Request for Quotation

RFQ NUMBER
DNRB12095

LINE	QUANTITY	UOP	CAT. NO.	ITEM NUMBER	UNIT PRICE	AMOUNT
***** ADDENDUM NO. 2 *****						
THIS ADDENDUM IS ISSUED TO:						
1.) PROVIDE ADDITIONS TO THE BIDDING DOCUMENTS,						
2.) PROVIDE ANSWERS TO TECHNICAL QUESTIONS						
3.) PROVIDE REVISED DRAWINGS						
**REVISED DRAWINGS ARE AVAILABLE BY VISITING						
HTTP://WWW.FILESANYWHERE.COM/FS/V.ASPX?V=8A6E67895E647						
A970A0. THEY ARE NOT CONTAINED IN HARD COPY FORMAT						
IN THIS DOCUMENT.						
4.) EXTEND THE BID OPENING DATE						
BID OPENING DATE IS EXTENDED TO: 02/14/2012						
BID OPENING TIME REMAINS: 1:30 PM						
***** END ADDENDUM NO. 2 *****

Canaan
 Valley Resort
 Renovations
 and Additions
 Davis,
 West Virginia

sheet number:
BD10

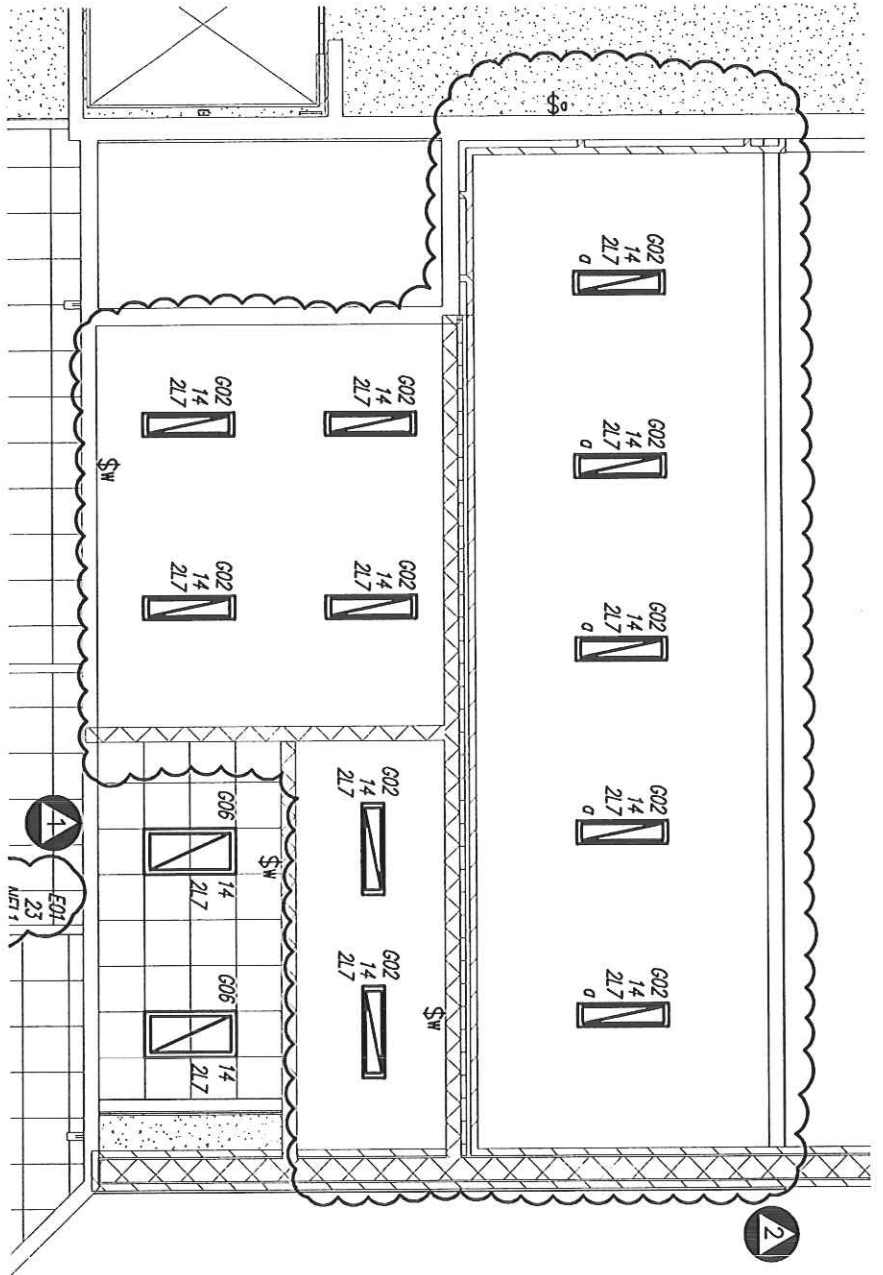
Question 16: In restrooms 274 & 275, the toilet accessories are not designated. Please advise.

Answer: *See bulletin drawing BD10 included in this addendum.*

sheet number:
BD12

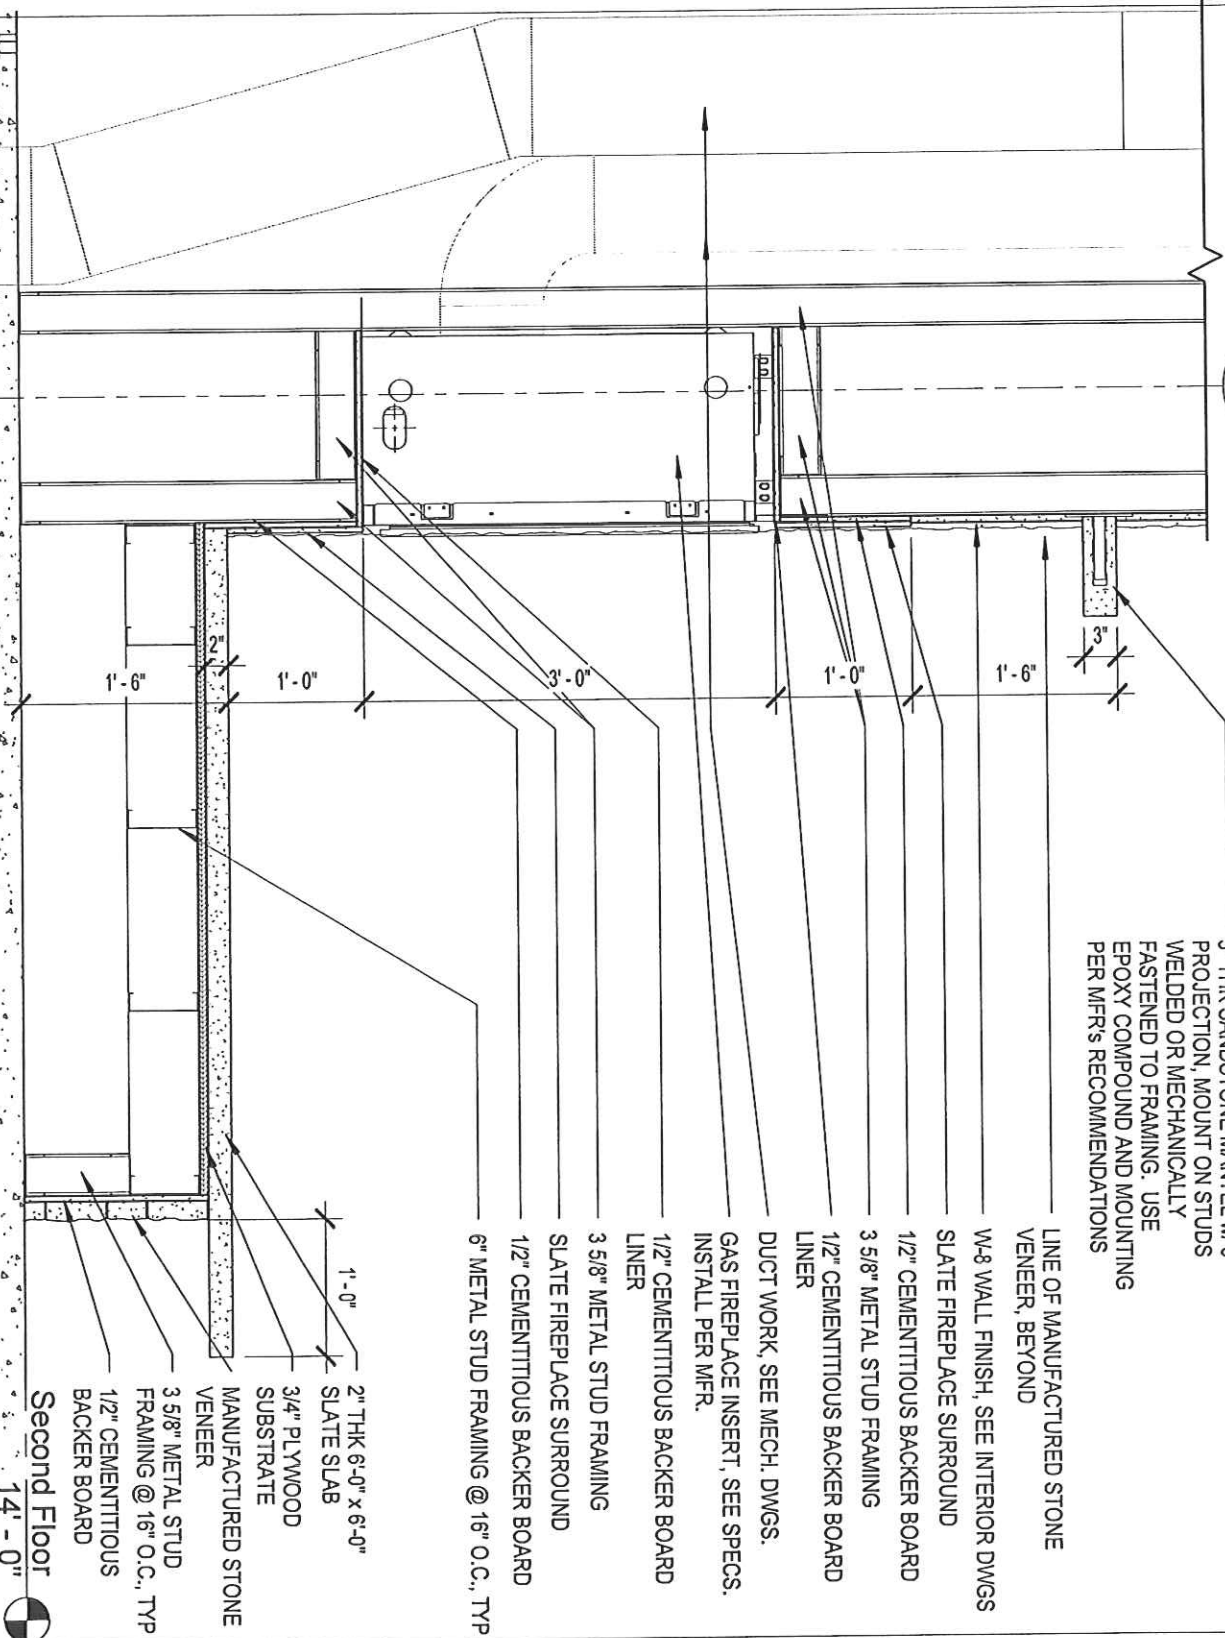
Question 28: At the two main curtainwall elevations, please provide information as to the building material. At the vertical intersection of curtainwalls SF5 / SF5a and SF6 / SF6a respectively (1H / A5.04); there is a building element that separates the two curtainwall sections. However, details, blow ups, etc. cannot be found to inform what materials are to be used. Specifically, is this to be wrapped in aluminum to match the curtainwall (This condition also presents itself at SF11 / SF12; SF16 / SF17 (1D & 1H / A5.01)?

Answer: *Refer to attached bulletin drawing BD12 for information.*

sheet number:
BD13

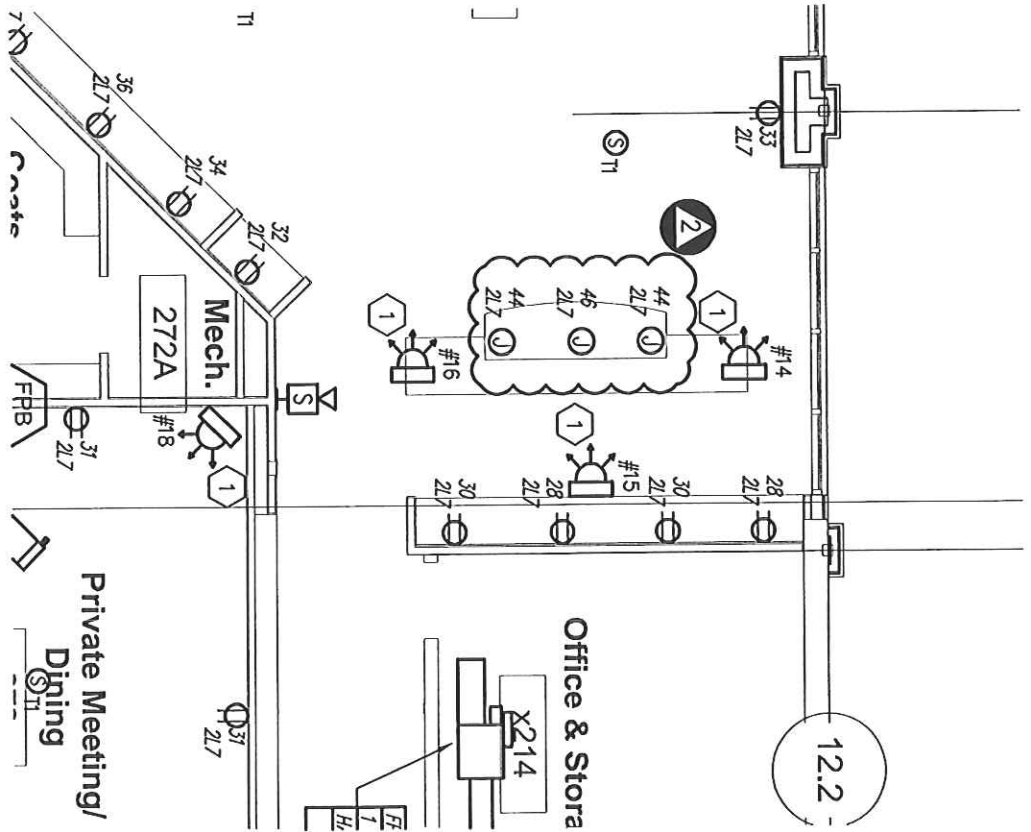
Question 32: 6/ID-8.4 – provide section through slate hearth slab showing support structure for the hearth and stone veneer below.

Question 33: 6/ID8.4 – provide wall section through fireplace? Fireplace construction appears to extend beyond column line B, as detailed in Section 7/ID8.4.

Answer: *Refer to attached bulletin drawing BD13 for information.*

Answer: *Refer to attached bulletin drawing BD13 for information.*

sheet number:
BD15

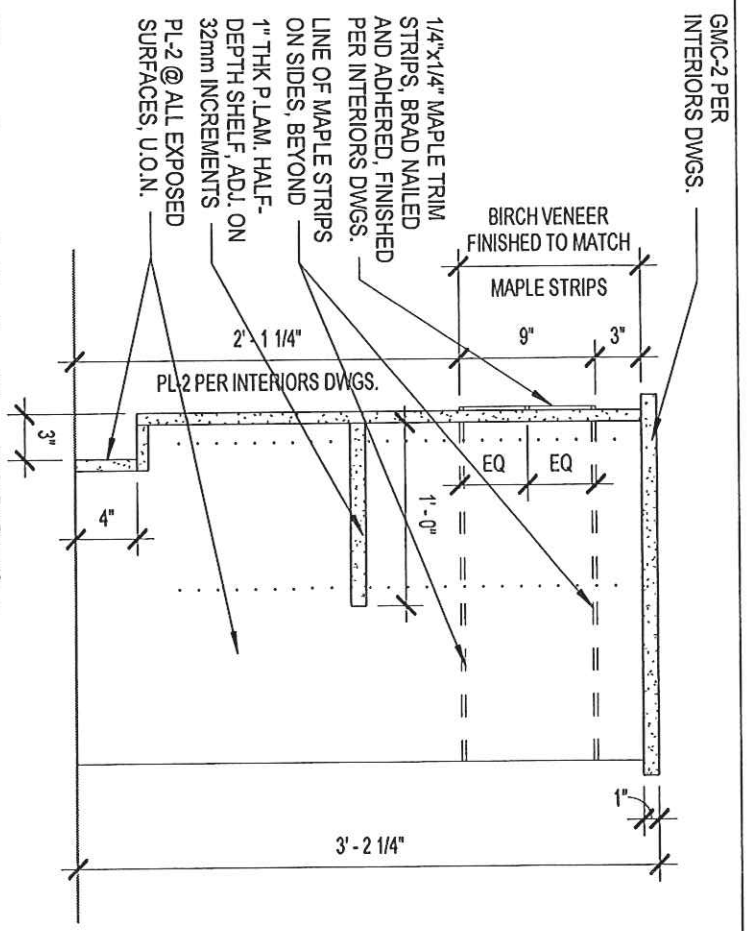
- Item 29:** BD15, add power supply for café equipment as noted.

sheet number: BD16

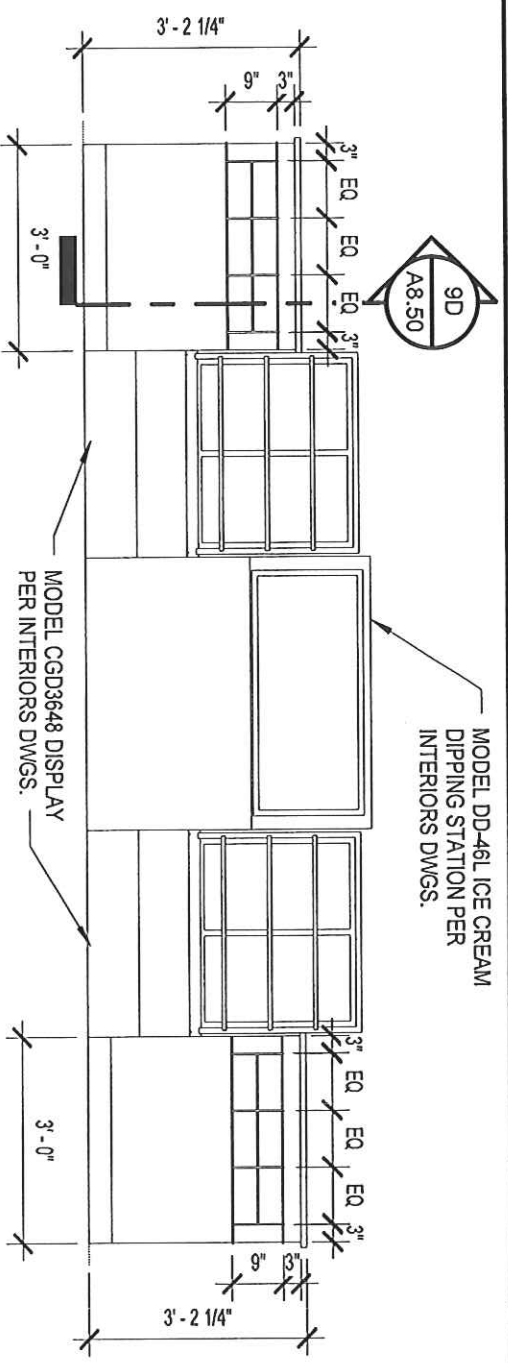
Question 36: 10/ID8.2 – provide sections/details for POS station construction.

Answer: *Refer to attached BD16 for information.*
